**BEAVER CREEK Coal Company**

RE: Amendment on Second Mining  
Trail Mountain No.9 Mine  
ACT/015/009  
Emery County, Utah

PROPOSED  
 TRAIL MOUNTAIN  
 SOUTH MAIN PILLAR EXTRACTION SEQUENCE

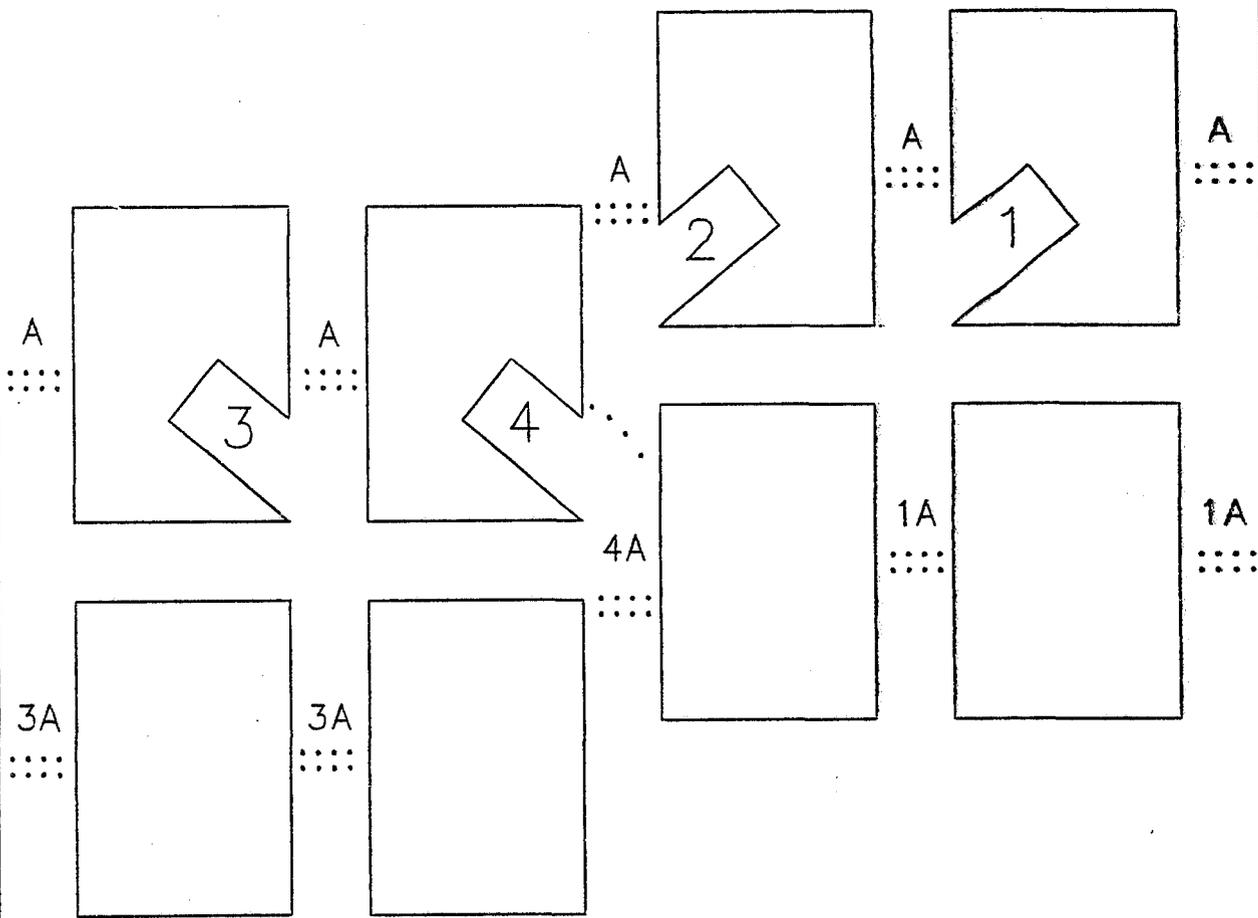
- (1) Plate 3-6, showing area of proposed limited extraction; (This should replace the previously submitted Plate 3-6 in Tract I);
- (2) A proposed pillar extraction sequence (This should be added to Appendix 12-1 of the Tract I Permit);
- (3) A corrected page 12-3 for Tract II Permit; (This sheet was inadvertently noted for Chapter 3 in my previous letter; Please replace page 3 of Chapter 12 in the Tract II Permit with this new page marked 12-3).
